United States Patent and Trademark Office

APPLICATION NO.	FILING DATE	FIRST NAMED INVENTOR	ATTORNEY DOCKET NO.	CONFIRMATION NO
10/614,442	07/03/2003	Shannon R. Schwenn	42522.0817	7736
75	12/03/2004	·	EXAM	INER
Joseph W. Pri	ce		WIEKER, AMA	ANDA FLYNN
PRICE, GESS	& UBELL			
Ste. 250			ART UNIT	PAPER NUMBER
2100 S.E. Main	St.		3743

DETAILED ACTION

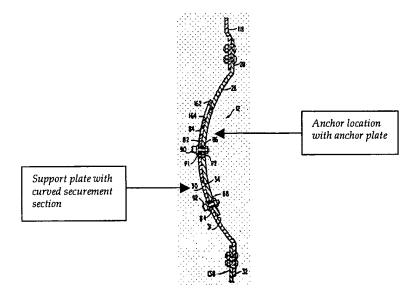
17. Claims 37-39 and 41-42 are rejected under 35 U.S.C. 102(b) as being anticipated by U.S. Patent Number 5,107,824 to Rogers et al.

Rogers et al. disclose an orthotic brace having an adjustable support plate assembly for positioning an appendant orthotic member at an operative position relative to an appendage of the user, comprising: a support plate (30) having a securement portion adjacent an anchor location/plate (26) operatively attached to the orthotic brace (110, 112) and a distal portion (32) for linking with the appendant orthotic member (130, 132) which is attachable to the user appendage (calf), the securement portion having a curved configuration (see Fig 5a) and a fastening structure (90, 92) that enables an adjustable movement relative to the anchor location to permit sliding movements of the distal portion towards and away from the user's upper torso. Rogers et al. also disclose a fastener member (166) for securing the curved configuration to the anchor location to maintain a desired position for the distal portion relative to the user. The anchor location/plate (26) is complementary to the curved configuration of the securement portion of the support plate (30), and receives the fastener member (166). The support plate (30) has a straight distal portion (32). The securement portion has a pair of elongated slots (82, 84) and a pair of fastener members (90, 92) is configured to fit within the elongated slots and fasten to the anchor location/plate (26).

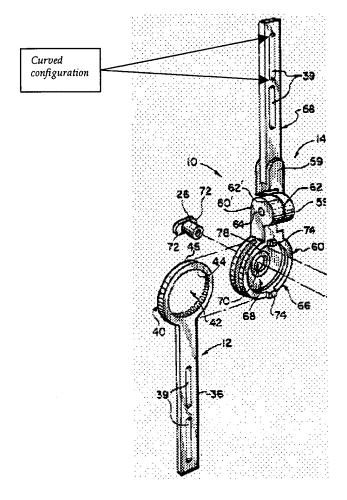
18. Claims 37, 39-40 and 42 are rejected under 35 U.S.C. 102(e) as being anticipated by U.S. Patent Number 6,203,511 to Johnson et al.

Johnson discloses an orthotic brace (106) having an adjustable support plate assembly for positioning an appendant orthotic member (38) at an operative position relative to an appendage of the user, comprising: a support plate (58/36) having a securement portion adjacent an anchor location on the orthotic brace (106) and a distal portion (36) for linking with the appendant orthotic member (38) which is attachable to the user appendage, the securement portion having a curved configuration (see below; slots 39 comprise a curved configuration at the top and bottom of the slot) and a fastening structure (105) that enables an adjustable movement relative to the anchor location to permit sliding movements of the distal portion towards and away from the user. Rogers et al. also disclose a fastener member (105) for securing the curved configuration to the anchor location to maintain a desired position for the distal portion relative to the user. The support plate (58/36) has a straight distal portion (36). The securement portion has a pair of elongated slots (39) and a pair of fastener members (105) is configured to fit within the elongated slots and fasten to the anchor location.
